TRANS/WP.29/GRSP/2001/16/Rev.1  
28 February 2002

PROPOSAL FOR DRAFT 04 SERIES OF AMENDMENTS TO REGULATION No. 44  
(Child restraints)

Revision 1

Transmitted by the Expert from France

Figure 0c

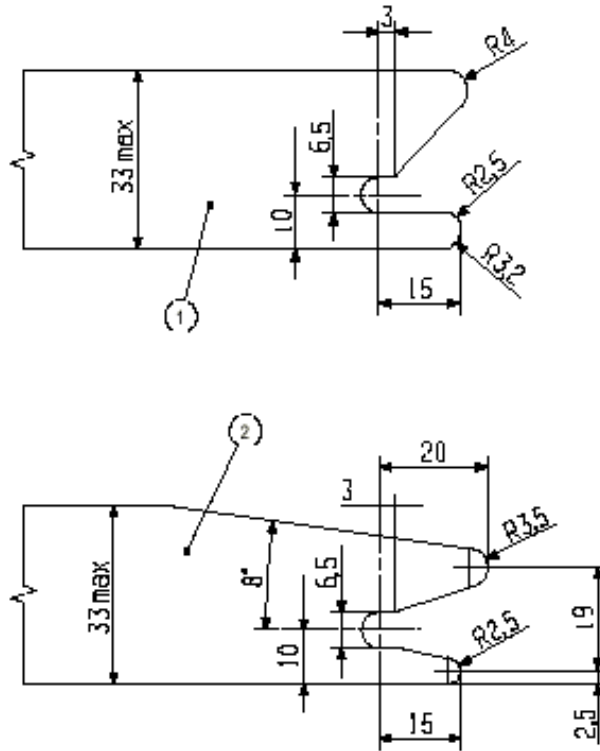
ISOFIX Attachments to anchorages may be according to examples shown in Figure 0c, or other appropriate designs that are part of a rigid mechanism having provision for adjustment, the nature of which is determined by the ISOFIX child restraint system manufacturer.

**Figure 0e: ISOFIX Top tether connector (hook type) dimensions**

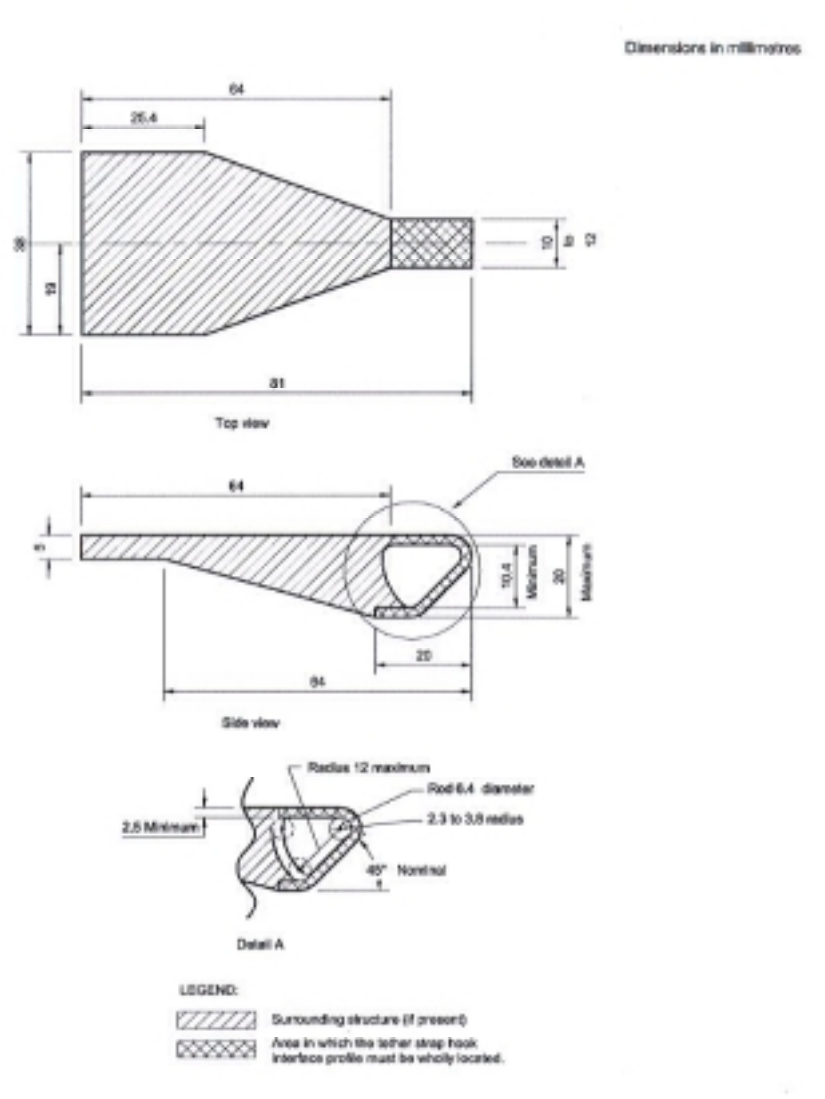
Engagement dimensions for ISOFIX top tether hooks are shown in Figure 0e.

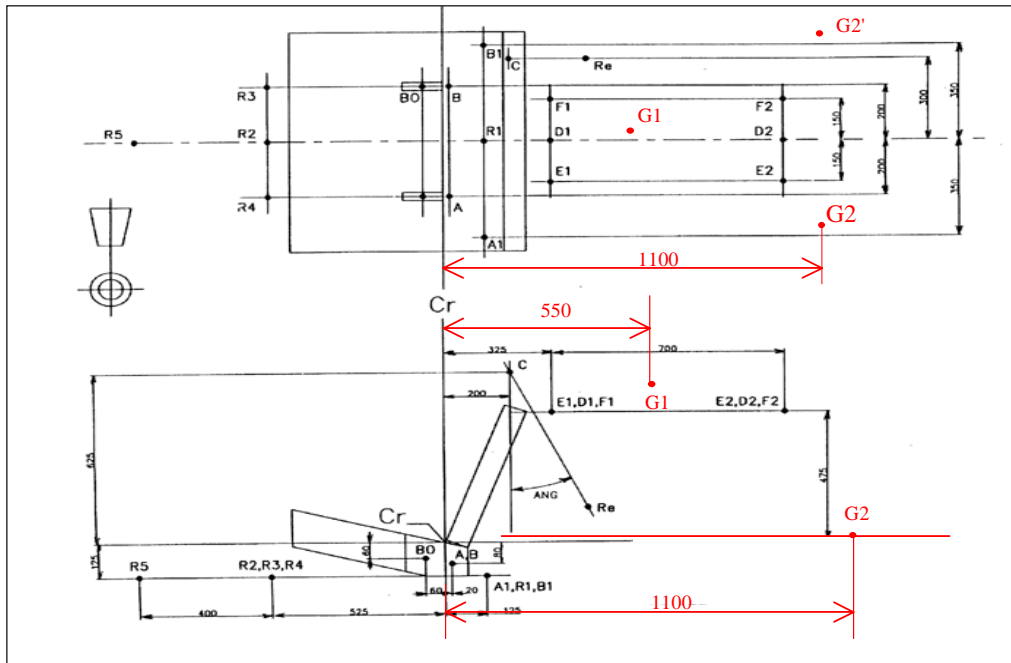
"1. The anchorages shall be positioned as shown in the figures 1, 2 and 3 below."

**"2.3. For child restraints using ISOFIX attachment, points H<sub>1</sub> and H<sub>2</sub>."**

**"9. For testing of child restraints with top tether, the anchorage G<sub>1</sub> or G<sub>2</sub> shall be used."**

Annex 21,

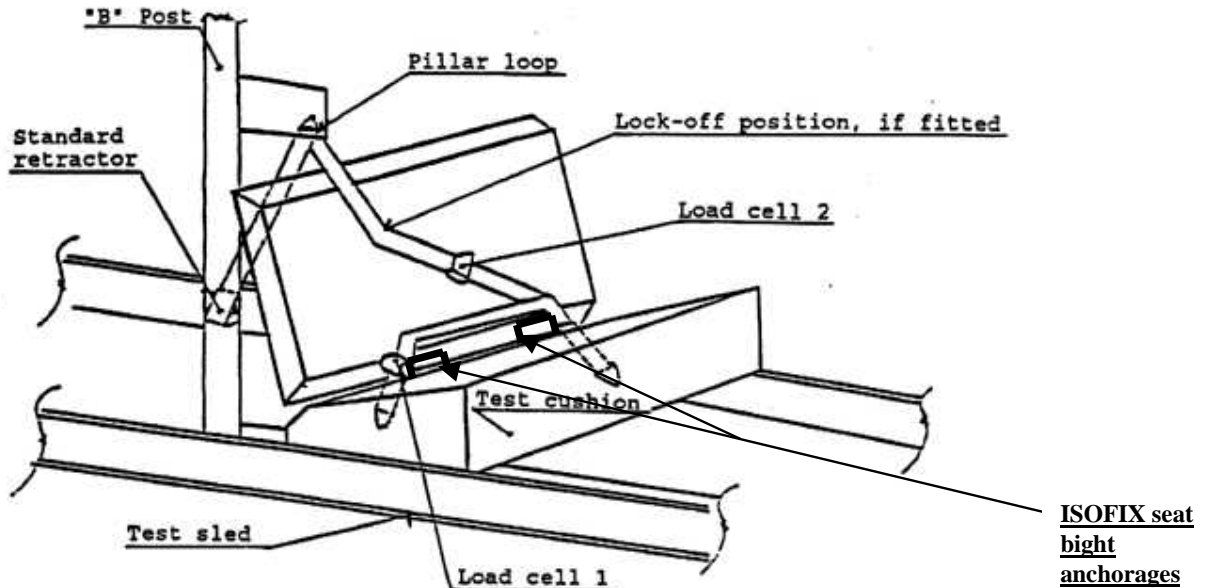
The figure, amend to read:
